Application No.	Applicant(s)			
Office Action Summary		10/788,972	SCHLAGENHAUF ET AL.			
		Examiner	Art Unit			
		Sara Addisu	3722			
The MAILING DATE of this communication appears on the cover sheet with the correspondence address Period for Reply						
A SHO WHIC - Exter after - If NO - Failur Any r	DRTENED STATUTORY PERIOD FOR REPLY HEVER IS LONGER, FROM THE MAILING DASIONS of time may be available under the provisions of 37 CFR 1.13 SIX (6) MONTHS from the mailing date of this communication period for reply is specified above, the maximum statutory period we to reply within the set or extended period for reply will, by statute, eply received by the Office later than three months after the mailing d patent term adjustment. See 37 CFR 1.704(b).	ATE OF THIS COMMUI 36(a). In no event, however, may rill apply and will expire SIX (6) M cause the application to become	NICATION. a reply be timely filed ONTHS from the mailing date of this communication. ABANDONED (35 U.S.C. § 133).

DETAILED ACTION

This Office Action is in response to the amendment filed 11/2/06. New claim 22 has been added. Currently, claims 1-22 are pending in this application.

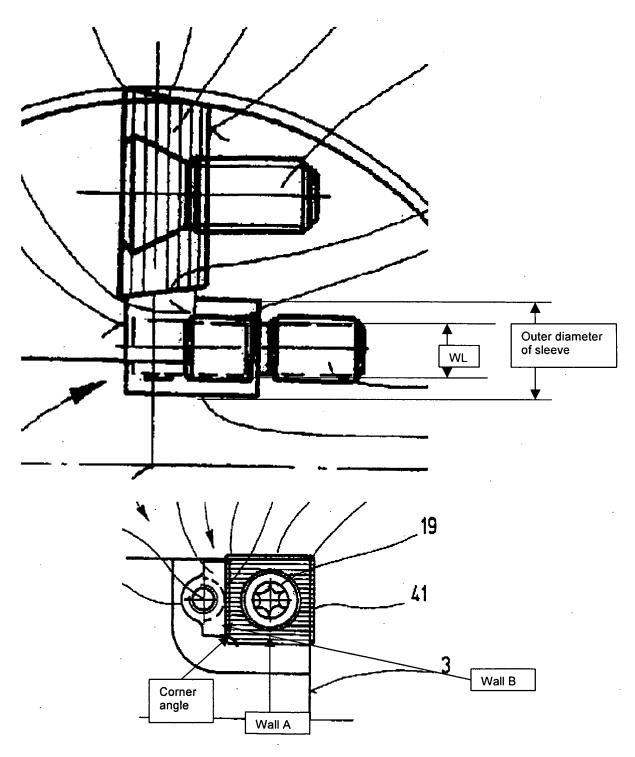
clamped flatly against a base surface of the pocket, a fine adjustment device having an adjustment element (27) that is supported on the lateral wall face (23) of the insert (11) and is displaceable relative to the insert via an adjusting screw arrangement ('198, figures 1, 2, 5a-5e and Col. 2, lines 28-37). KRESS also teaches adjusting screw (31) having left-hand external threaded portion (43 and right-hand external threaded portion (45) held through opening of the tool body ('198, figure 5a and col. 3, lines 42-50). Furthermore, KRESS teaches in figure 1, the adjusting screw (31) being placed into the through opening of the tool from the side facing the base surface. KRESS also teaches the set screw (31) is accessible from the right (i.e. can be actuated from the other side opposite the base) ('198, col. 2, lines 44-47). Regarding claim 5, the adjusting element (27) is seated flatly (via surface 29) on the lateral wall (23) of the cutting insert (11). Regarding claim 8, KRESS teaches the pocket having two supporting walls (A & B: where B is formed by 27) that accepts the cutting insert which together enclose an angle that corresponds to a corner angle of the cutting insert. Regarding claims 9 and 10, KRESS teaches the cylinderical through opening in the tool holder extends along an axis that is placed at an angle (90 degrees) to the base surface of the pocket of the tool holder. Regarding claim 14, KRESS discloses the claimed invention (i.e., threaded bolt), except for the winding of the threaded bolt (consequently also the complementary threaded sleeve after the modification) having a size in the range of M.08-M16 or M1.2-M16). It would have been obvious to one having ordinary skill in the art at the time the invention was made to choose different screws having different ranges of thread winding depending on the machining operation taking place (e.g. depending on the

quality of finished surface of the workpiece desired) such that one can determine how far and how controlled the insert needs to extend/be adjusted, because it has been held that where the general conditions are disclosed in the prior art, discovering the optimum or working range involves only routine skill in the art.

However, KRESS ('198) fail to teach the adjusting screw having a threaded sleeve.

KRESS et al. ('724) teaches a cutting tool having an adjusting screw comprising a threaded sleeve (5) held with play in a smooth through opening of the tool body and being in functional engagement with a screw part (6) ('724, figures 1 and 6). KRESS et al. also teaches the threaded segment of the screw part/bolt (6) going over a step into a wedge-shaped head (4) that forms the adjustment element ('724, figures 1 and 6). Furthermore, KRESS et al. teaches the adjusting element (27) ibeing seated flatly (via surface 41) on the lateral wall of the cutting insert (3).

Therefore, it would have been obvious to one of ordinary skill in the art at the time of the invention was made to modify the adjustment means of KRESS' invention such that it has a sleeve, as taught by KRESS et al. for the purpose eliminating the added manufacturing step (i.e. making the threading inside the tool body to engage the differential screw) as well as to eliminate any vibration between that may be caused overtime between the joint threading of the two pieces thus leading do improved cut on the workpiece.
